# Construction Traffic Management Plan

Pymont East – Stage 1 – Demolition

Rev 02

# REVIEW COMMENTS SHEET

Figure 10 - Pymont East Daily Light Vehicle Movements

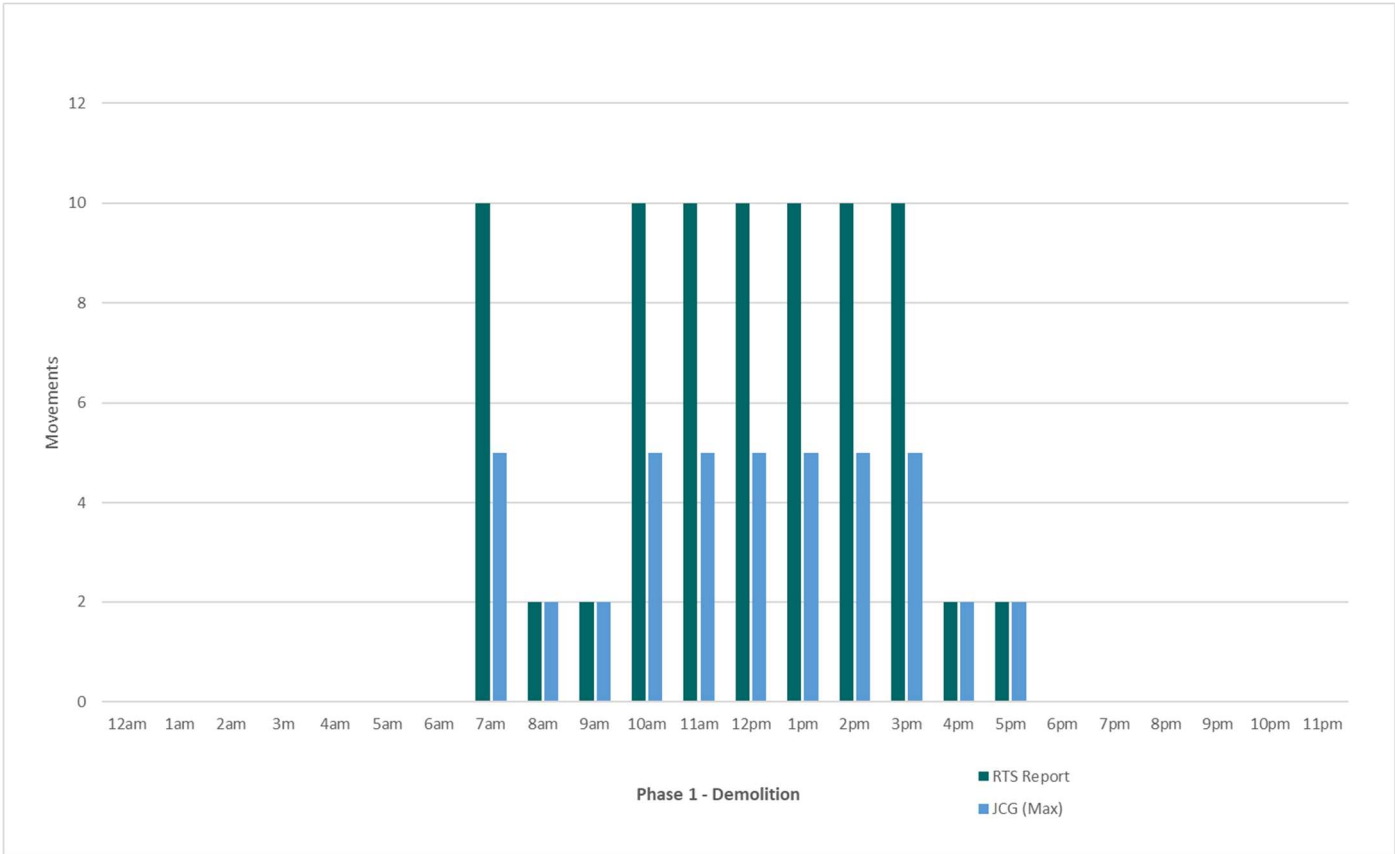
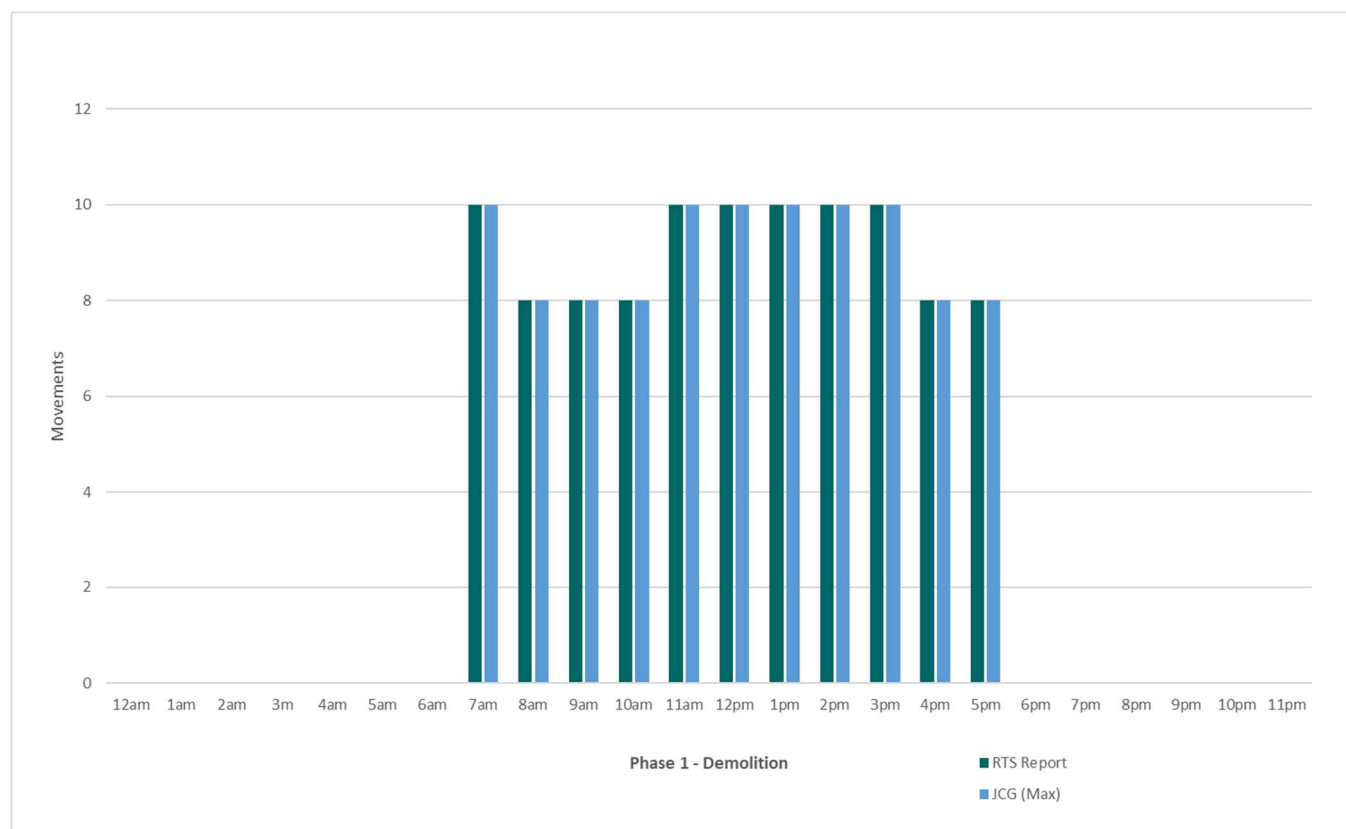
| DOCUMENT NO. | TITLE | VER | STATUS | NO.   | DATE       | COMPANY | RAISED BY | REVIEW DOC. NO.*                     | DOCUMENT REF*             | DEED REF* | COMMENTS / RESPONSE   | COMMENT CATEGORY* | CLOSED OUT |
|--------------|-------|-----|--------|-------|------------|---------|-----------|--------------------------------------|---------------------------|-----------|---|-------------------|------------|
|              |       |     |        | 07    | 3/03/2023  | RMS     | HYOUSAF   | SMWSTETP-JCG-PYR-SN150-TF-PLN-002060 | Section 5.6 Table 9       | NA        | Recheck/clarify the numbers in table 9. My understanding of EIS2 Chapter 6 figure 6-9 is that blue bar shows in+out movements, for example the number '5' shows 3 in and 2 out movements. Same for all LVs and other stages. Also add the word 'movements' in first column with LV and HV.  | Observation       | Y          |

| DOCUMENT NO.                         | TITLE  | VER   | STATUS | NO.   | DATE       | COMPANY | RAISED BY | REVIEW DOC. NO.*                     | DOCUMENT REF*      | DEED REF*                      | COMMENTS / RESPONSE   | COMMENT CATEGORY* | CLOSED OUT |
|--------------------------------------|--|-------|--------|-------|------------|---------|-----------|--------------------------------------|--------------------|--------------------------------|---|-------------------|------------|
|                                      |  |       |        | 05.01 | 5/04/2023  | JCG     | NBRYANT   | .                                    | General            | .                              | Table 9 has been replaced with Figure 9 & 10 for clarity.   | Observation       | Y          |

| DOCUMENT NO. | TITLE | VER | STATUS | NO.   | DATE       | COMPANY | RAISED BY | REVIEW DOC. NO.*                     | DOCUMENT REF*             | DEED REF* | COMMENTS / RESPONSE   | COMMENT CATEGORY* | CLOSED OUT |
|--------------|-------|-----|--------|-------|------------|---------|-----------|--------------------------------------|---------------------------|-----------|---|-------------------|------------|
|              |       |     |        | 07.01 | 5/04/2023  | JCG     | NBRYANT   | SMWSTETP-JCG-PYR-SN150-TF-PLN-002060 | Section 5.6 Table 9       | NA        | Table 9 has been replaced with Figure 9 & 10 for clarity.   | Observation       | Y          |

| DOCUMENT NO. | TITLE | VER | STATUS | NO.   | DATE       | COMPANY | RAISED BY | REVIEW DOC. NO.*                     | DOCUMENT REF*   | DEED REF* | COMMENTS / RESPONSE  | COMMENT CATEGORY* | CLOSED OUT |
|--------------|-------|-----|--------|-------|------------|---------|-----------|--------------------------------------|---|-----------|--|-------------------|------------|
|              |       |     |        | 29.01 | 5/04/2023  | JCG     | NBRYANT   | SMWSTETP-JCG-PYR-SN150-TF-PLN-002060 | 5.6 Construction Traffic Generation                             | NA        | Table 9 has been replaced with Figure 9 & 10 for clarity.  | Observation       | Y          |

**Figure 2.1: Existing Driveways To be Used during Demolition**

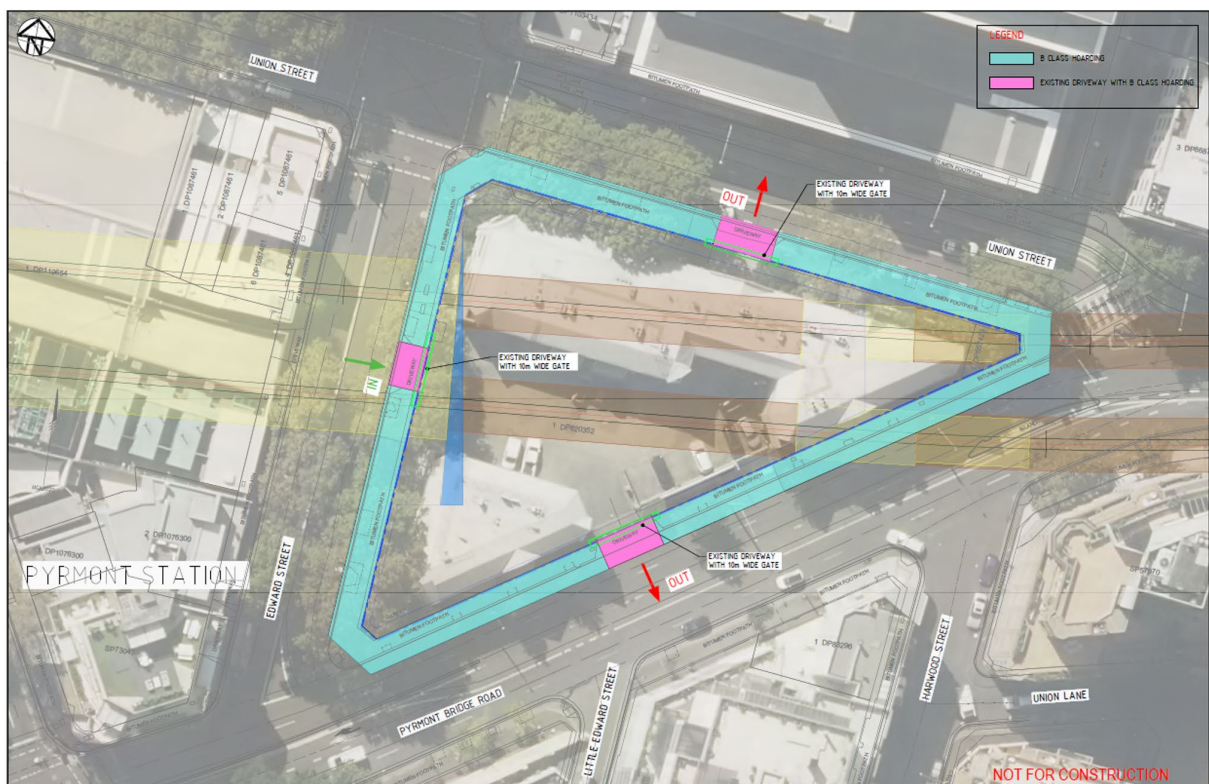
| Item No. | Location                   | Descriptions of Findings   | Photo  | Likelihood | Severity | Risk Rating | Designer Response   |
|----------|----------------------------|--|--|------------|----------|-------------|---|
| 1.       | Pymont Bridge Rd eastbound | <p>Trucks (12.5m) turning left from Pymont Bridge Road into Edward Street are required to straddle across two lanes.</p> <p>Vehicles traveling in the adjacent lane may not be aware of the truck taking up two lanes prior to turning left into Edward Street and this could cause side swipe crashes.</p> <p>However, we note that this movement is permitted in the NSW road rules for trucks with the correct signage.</p> |  | Rare       | Minor    | Negligible  | <p>JCG JV to ensure construction vehicles longer than 7.5m are to display a Do Not Overtake Turning Vehicle sign at the back, in accordance with Road Rule 32.</p> <div>  </div> |
